Document last modified: 6/12/15

<u>Page</u>	<u>Correction</u>
iii	Karl Kerchner , Lebanon County Conservation District
3	URL link has been changed to: http://www.deq.virginia.gov/Portals/0/DEQ/Water/Publications/TechBulletin1.pdf
35	3 rd paragraph, 1 st sentence: 2,000 cubic feet storage capacity (with 12” freeboard) for each tributary drainage acre.
62	Last paragraph, 1st sentence: “As with other sediment barriers, compost socks should not be placed in areas of concentrated flow. They should be placed parallel...”

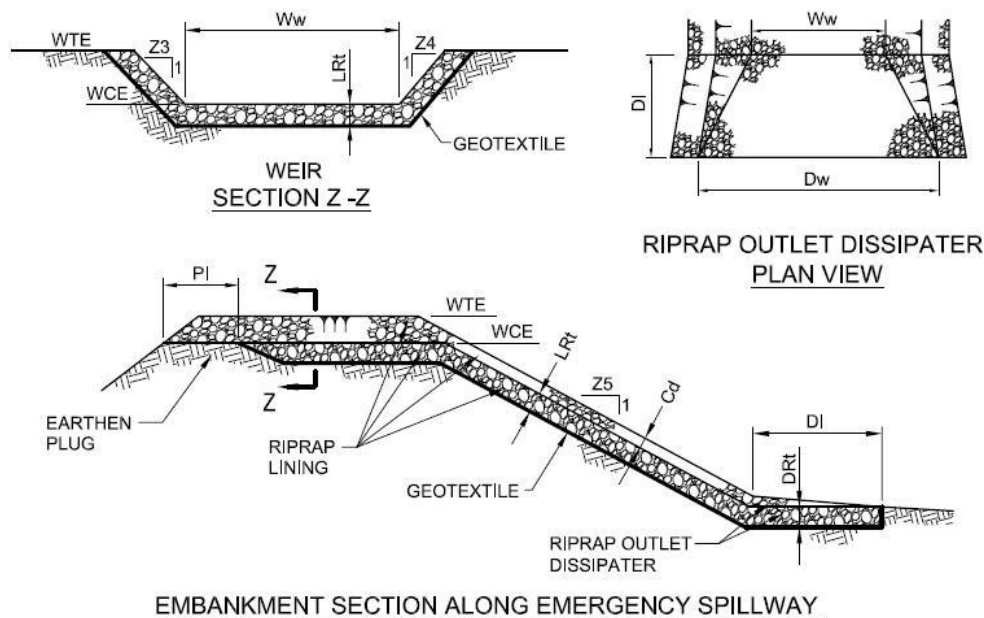
Item 13 – 1st sentence should refer to Standard Construction Detail # 7-17.

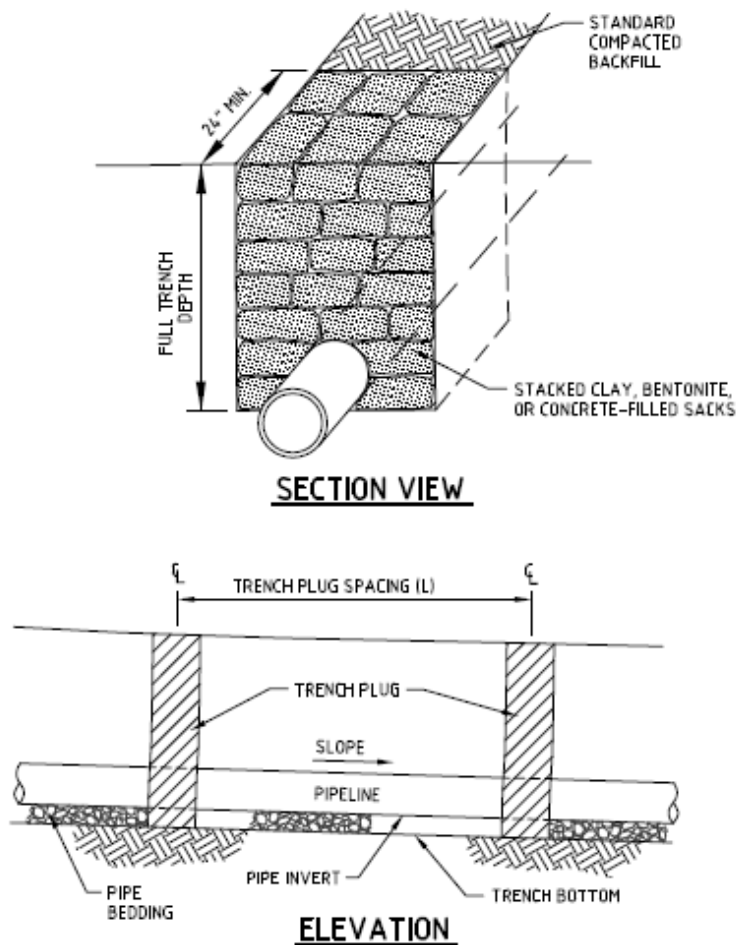
229 For equation: $Q_f = \frac{0.464}{n} D^{8/3} S^{1/2}$

n = Manning's "n"
